Lincoln School Apartments NYSERDA Early Design Support

Report Date:
July 1, 2025

Executive Summary

Fig: Preliminary Modeling Results

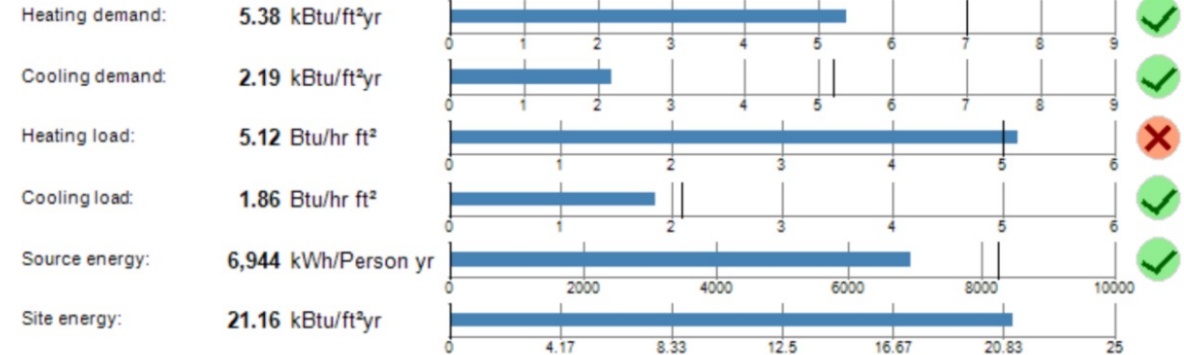
The initial design meetings create an initial concept design with target insulation levels and mechanical systems and the first energy model is created. This design was close to meeting all Phius targets but failed to meet the heating load target initially due to the Climate Zone 6 impacting heating load on the building.

Fig: Modeling Revision 2 Results – Meeting Phius Standards

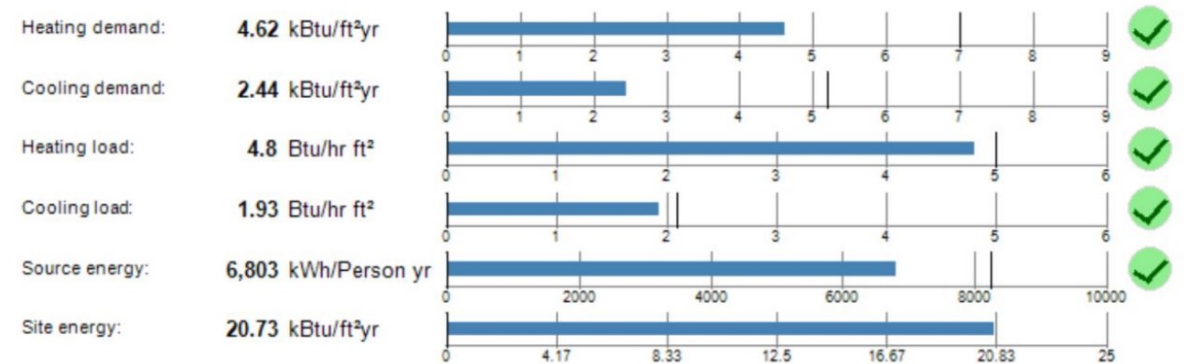
- Unitary ventilation rates were reduced from 55 CFM to 50 CFM per dwelling
- Eliminated perimeter thermal bridge
- Above grade wall insulation increased:

Modified Effective R-values Modeled		
Walls to Exterior	R- 32	2x6 wood Studs with 5.5” Batt insulation + 2.5” Zip R-12.6 Exterior insulation.

Fig: Section Detail
Drawing by Sanders Architects

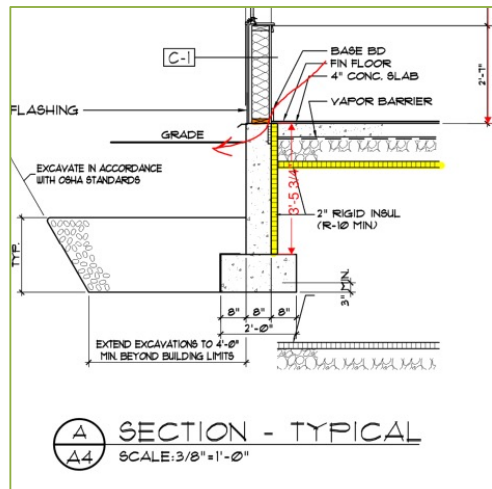
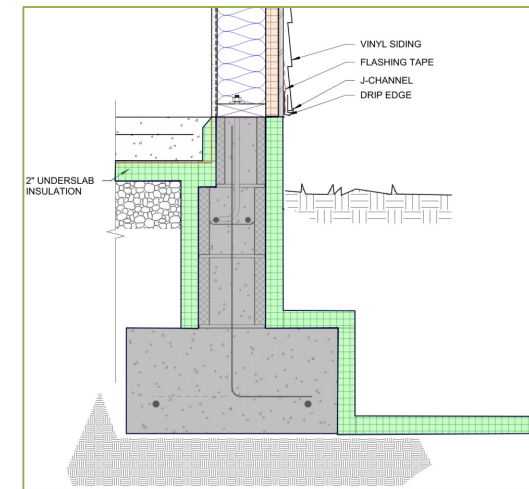
The originally designed slab edge detail is a thermal bridge and a potential condensation risk. We recommended eliminating this thermal bridge completely because of how tight the heating target is. To achieve this, additional vertical insulation on the exterior as well as horizontal insulation for a minimum of 4 feet as shown below in the thermal bridge free detail.

- **Slab:** R-10 continuous under slab insulation – 2” Rigid XPS under 8” Gravel.
- **Slab edge insulation:** R-10 wrapped down exterior foundation wall connecting with exterior rigid wall insulation

Fig: Section Detail
Drawing by Sanders Architects

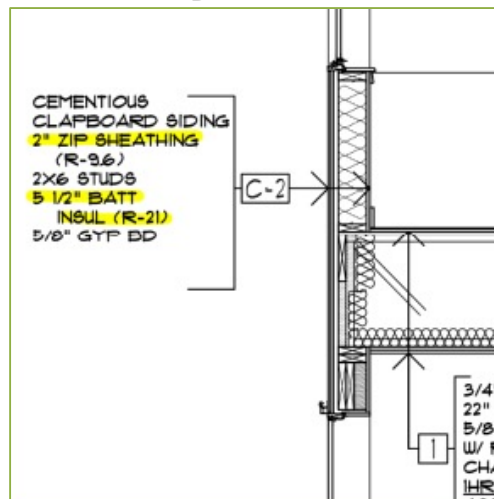
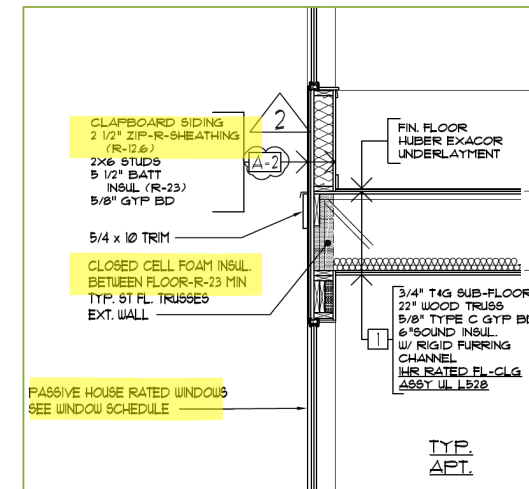
2 x 6 Wood Stud Walls: 2" Zip Sheathing [R-9.6] as shown in the drawing archives a total R-value of 28.5 for the wall assembly. Changing the exterior continuous insulation to 2.5" Zip Sheathing [R-12.6] results in a total R-value of ~ 32, which helps meet the heating load targets. This change is driven by the more stringent requirements and extra heat loss in climate zone 6.

- R-12.6 Zip-R Sheathing, 2.5"
- Closed cell foam insulation at rim/band joist to maintain

Fig: Section Detail
Drawing by Sanders Architects

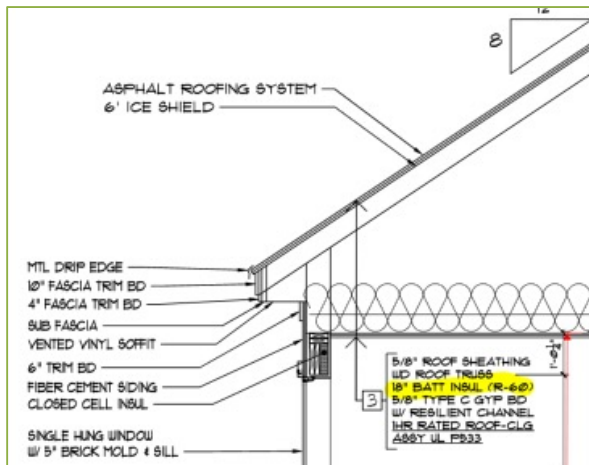
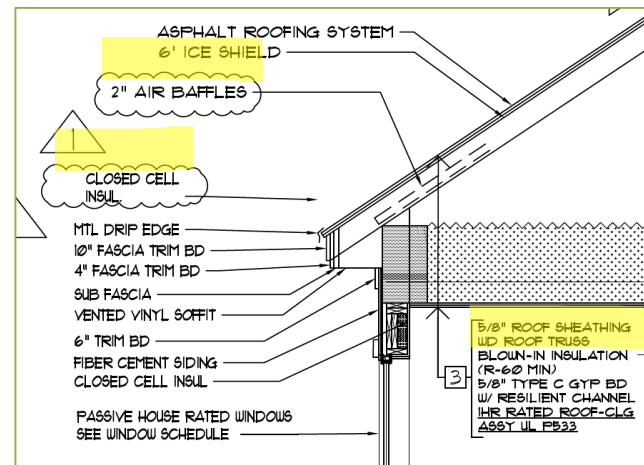
The original detail called for a vented attic with roof truss system and 18" Batt Insulation [R-60] over 5/8" Type C Gyp board. Recommendations and final details shown below.

- It may be difficult to achieve grade 1 installation with batts between framing. Consider loose fill blown in cellulose insulation.
- Indicate what the air barrier at the attic will be and fully detail and sequence air barrier installation at ceiling.
- Call for insulation baffle at soffit vent and closed cell foam at edge of attic.

Fig: Original Wall Section
Drawings by Sanders Architects

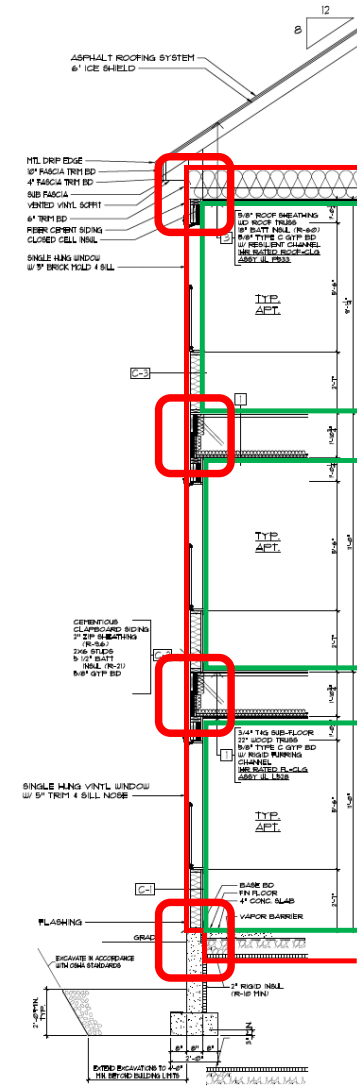
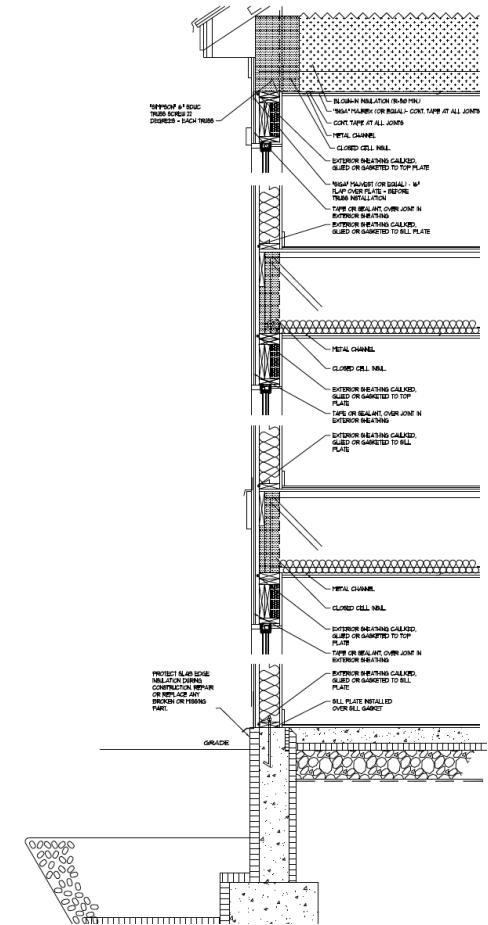
Major building connection points are potential thermal bridge locations. Conducting a red pen review and outline where all building assemblies meet can identify details to consider for thermal and air barrier continuity.

- Foundation to wall transition
- Wall to roof transition
- Siding attachments [Brick Ties]
- Canopy attachments

-  Additional detailing required for thermal-bridge-free construction
-  Thermal and air control boundary - 0.06 CFM/ft² @50PA
-  Compartmentalization boundary - 0.3 CFM/ft² @50PA

Fig: Back Porch Section Detail
Drawing by Sanders Architects

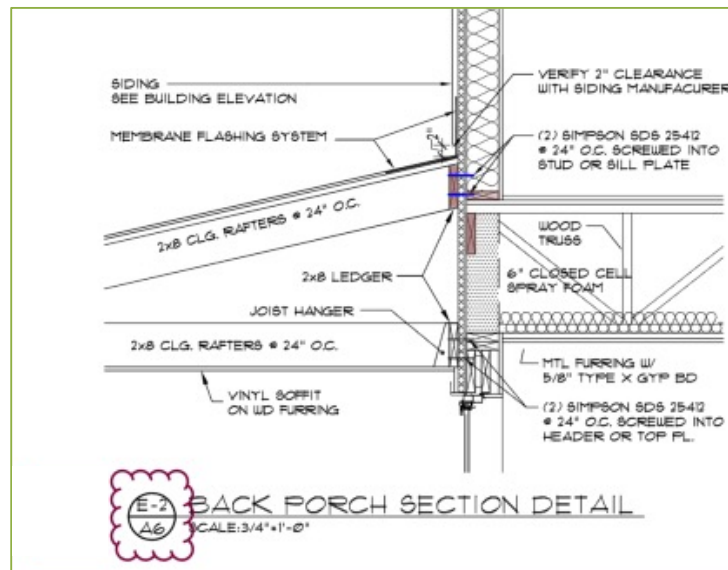
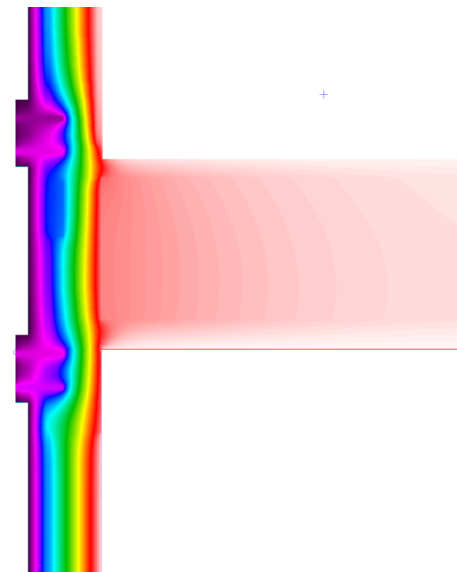
Psi for WUFI (btu/hr.ft.F)
0.191

Recommended Modification: It is best practice that anytime structural fasteners come through the exterior sheathing, to call for a coating of spray foam at the interior side of the fasteners to eliminate any risk of condensation.

Fig: Exterior Wall w/ Porch Section Detail
Drawing by Sanders Architects

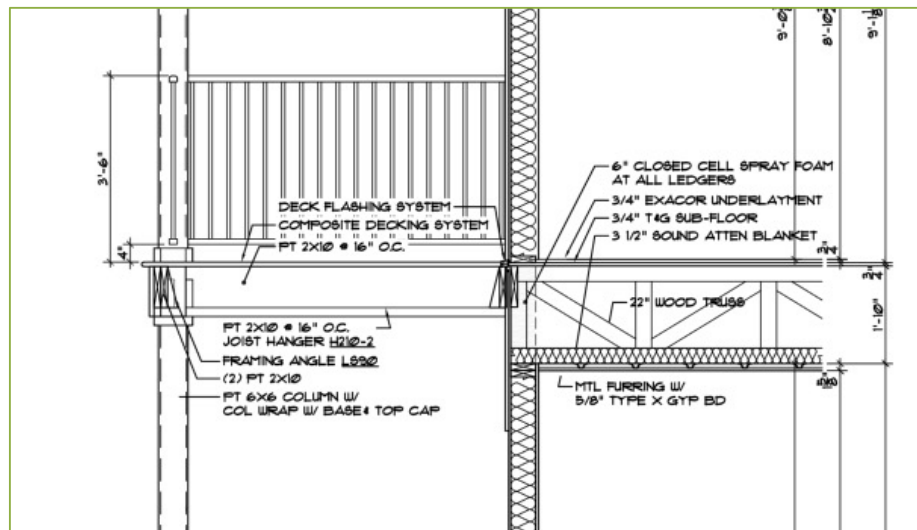
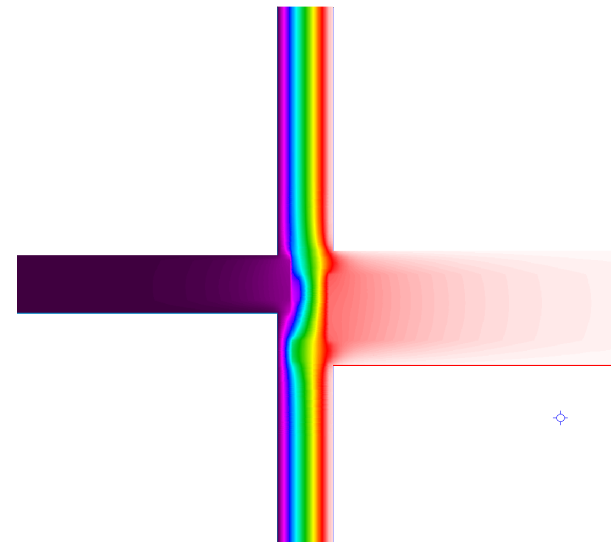
Not all thermal bridges are impactful enough to need to change and can be accounted for as energy loss in the model. The Thermal Bridge at the balcony junctions was analyzed, and the thermal escape PSI value was accounted for in the energy model. This can be the case due to structural constraints and must be assessed to reduce potential condensation concerns or energy use.

Psi for WUFI (btu/hr.ft.F)
0.113

Fig: Third Floor Plumbing Plan
Drawing by Sanders Architects

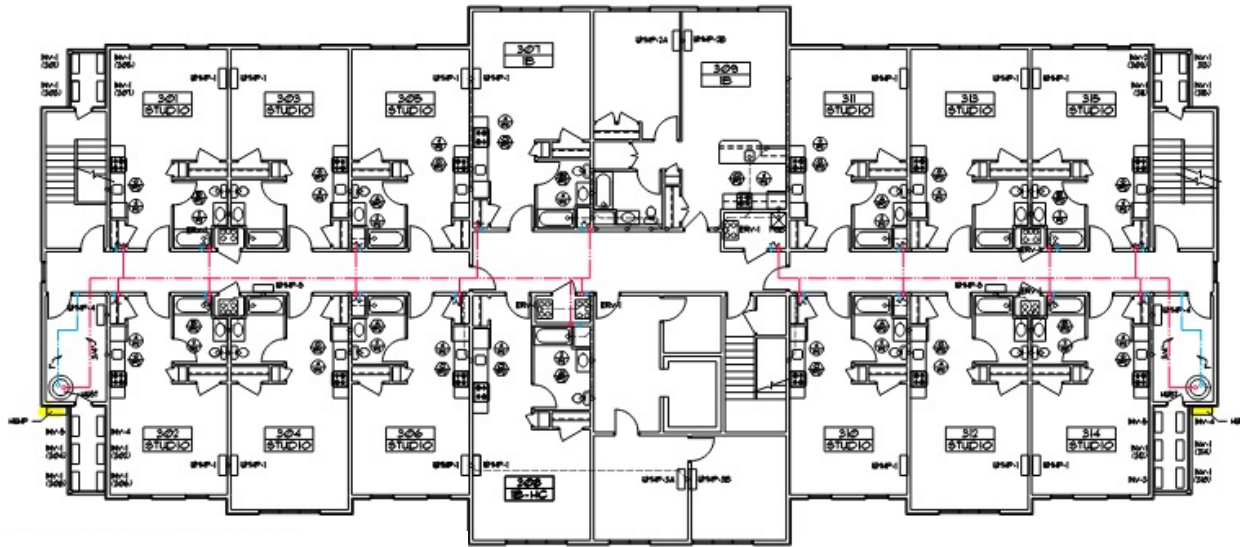
- This is a semi-central design with one SANCO2 system per wing on each floor for a total of 6 SANCO2 systems. Outdoor units for the HPWH are located on mechanical balconies on each floor.
- In-unit distribution must meet the relevant DOE ZERH storage and time-to-hot requirement. To be reviewed when unit plans are available.
- Hot water piping increased cooling loads in the building, keeping distribution compact reduces energy use in the model.

- DOE Zero Energy Ready Requirement: Central distribution pump shall be temperature and demand based.
- Plumbing Fixtures: No specific requirements for flow rates, however, Plius encourages the use of all Water Sense labeled fixtures for toilets, lavatory faucets, and showerheads.
